### FERGUSON MALONE ARCHITECTURE

> Re: Tracy Calvan & Gordon Fearey Barn Renovation Application No. 269 (99 Bracebridge Lane, Irvington NY) Parcel No. 2.20-4-6 Revisions

Attached please find proposed revisions for the Calvan Fearey House project at 99 Bracebridge Lane. The project was submitted and approved by the ARB in April 2019, and Revisions were submitted and approved in December 2020. Below is a list of additional revision.

A - 0.20

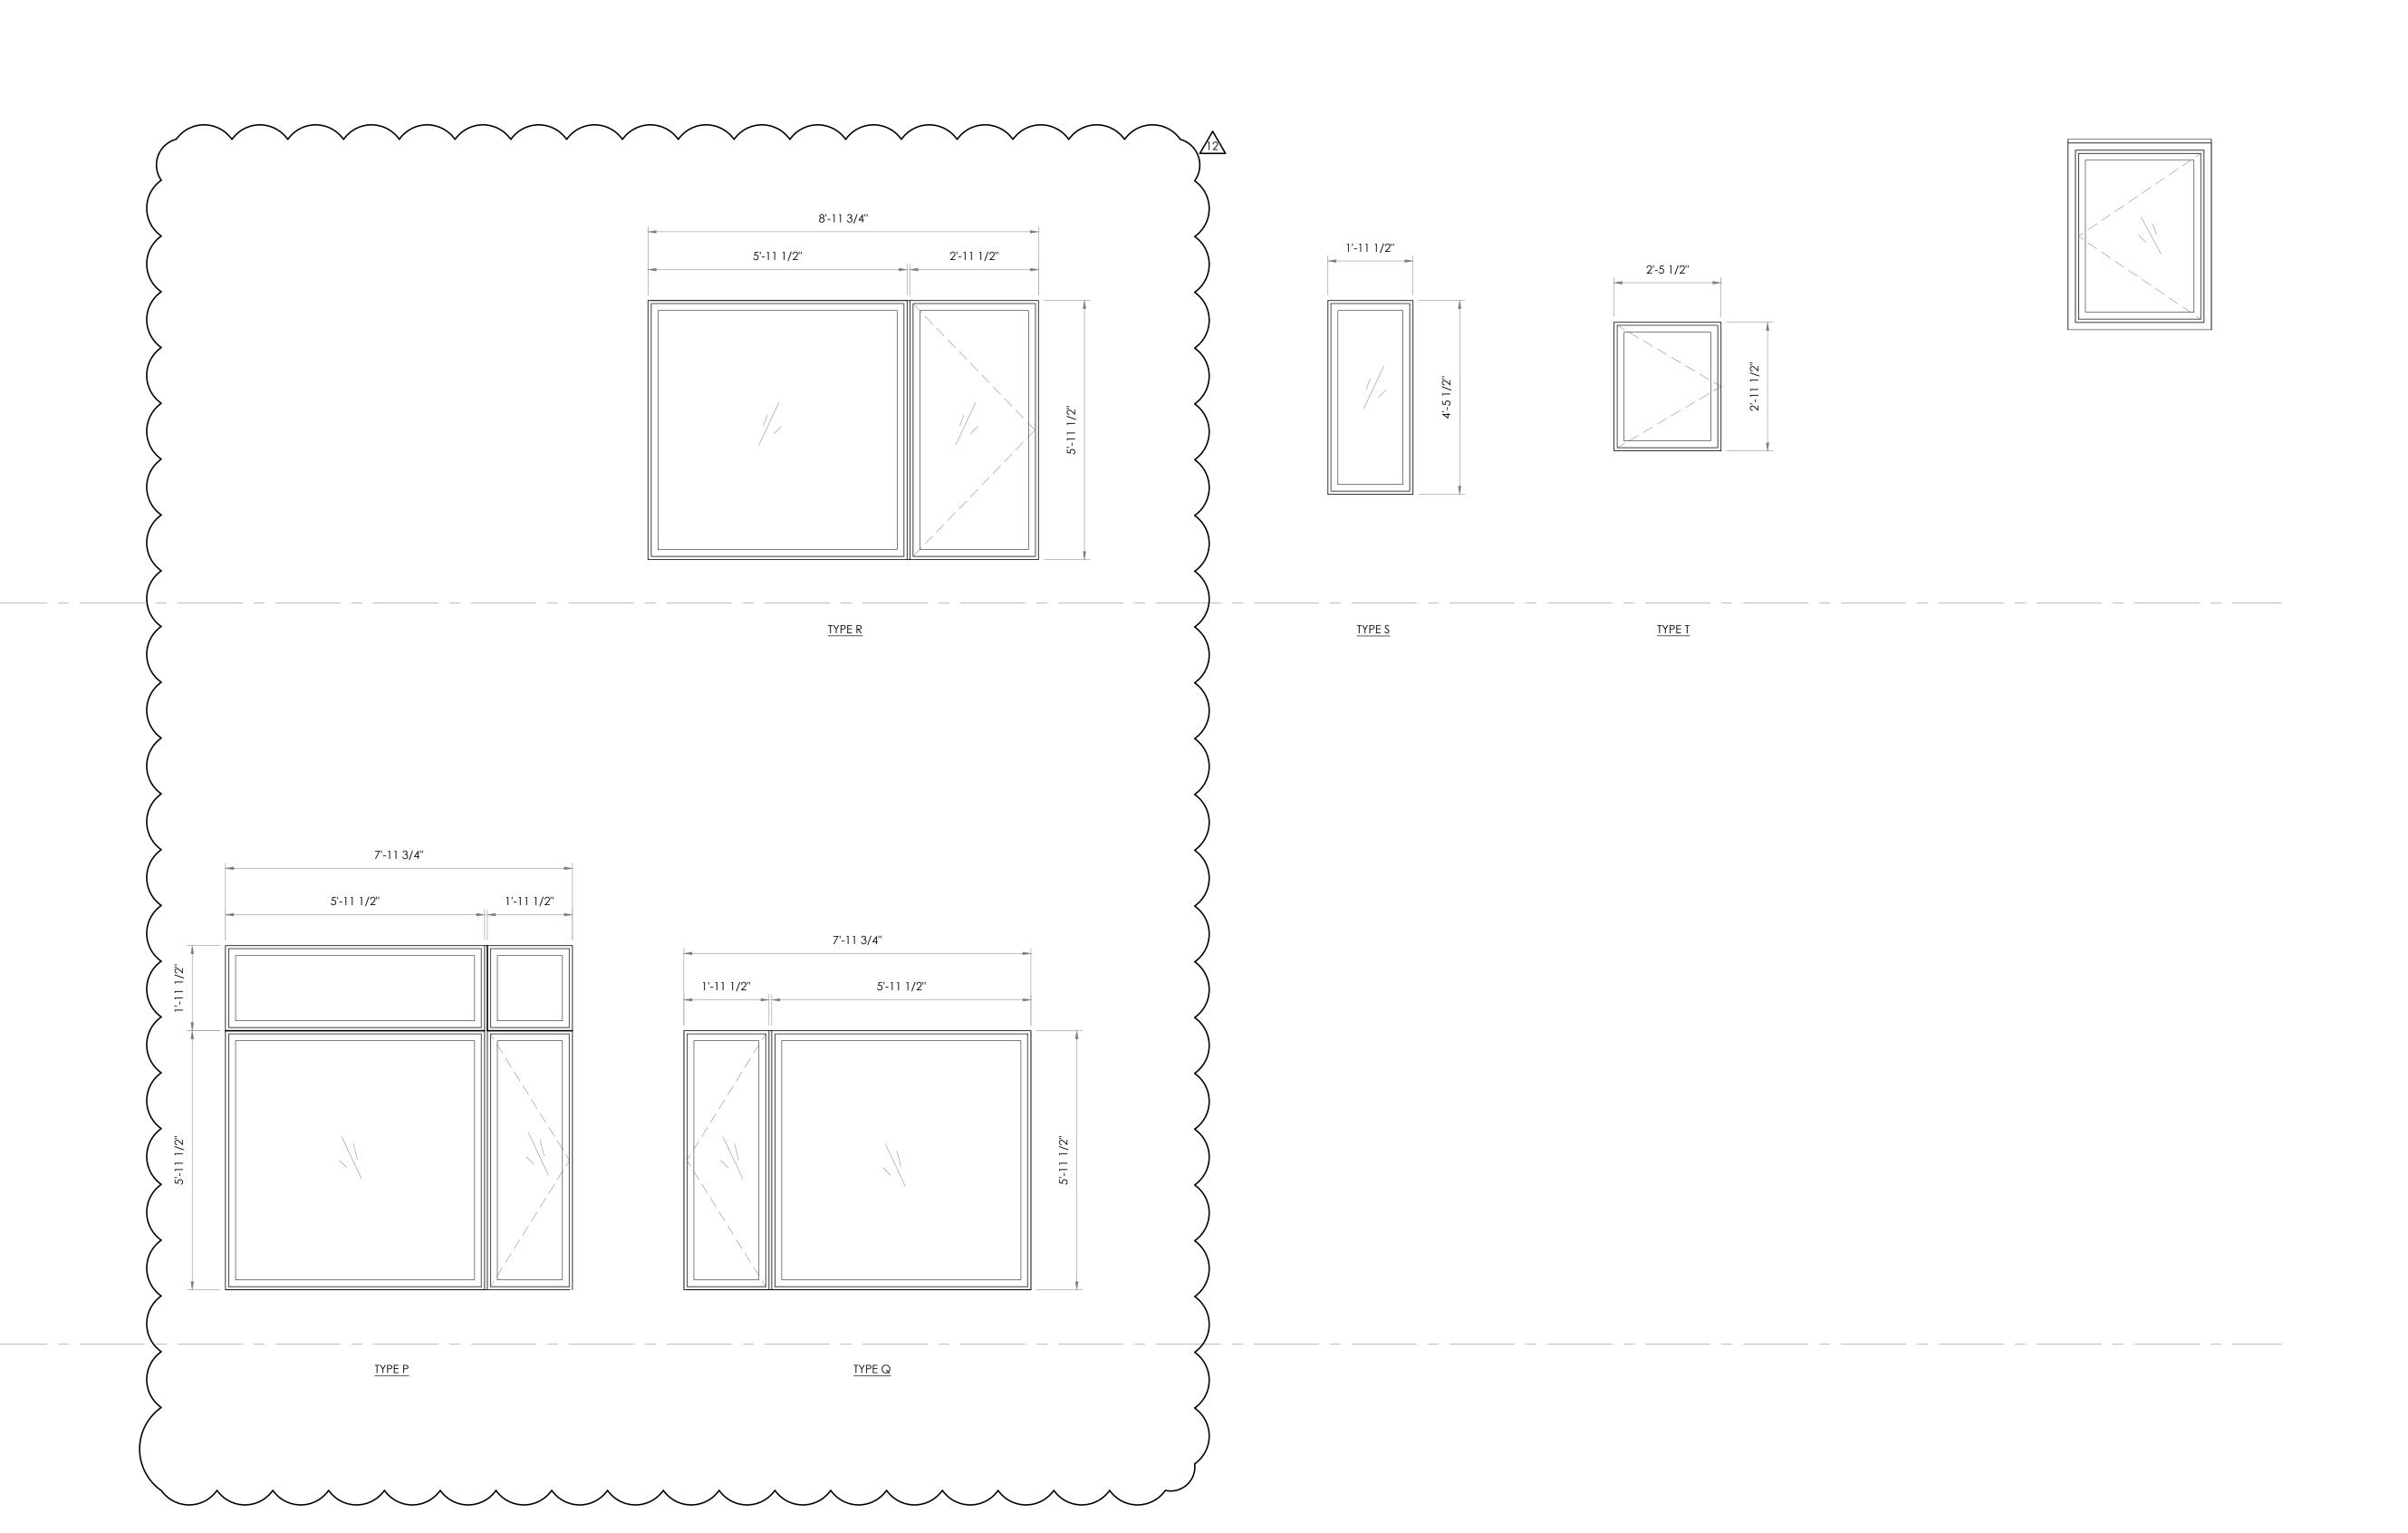
- 1. The proposed vertical cedar siding and existing siding have been replaced with Hardie Panel Vertical Board & Batten Siding.
- 2. The previously approved window assemblies at living room and master bedroom have been revised to a different configuration to reduce the number of windows and to be more in line with the proposed windows assemblies design at the addition.
- 3. The proposed sliding door at the South façade in the dining room has been replaced with a French outswing door.
- 4. A new operable window has been added at the North façade in the guest Office/Bedroom. The additional window is from the same manufacturer and line of all the previously approved windows throughout the house and the addition.
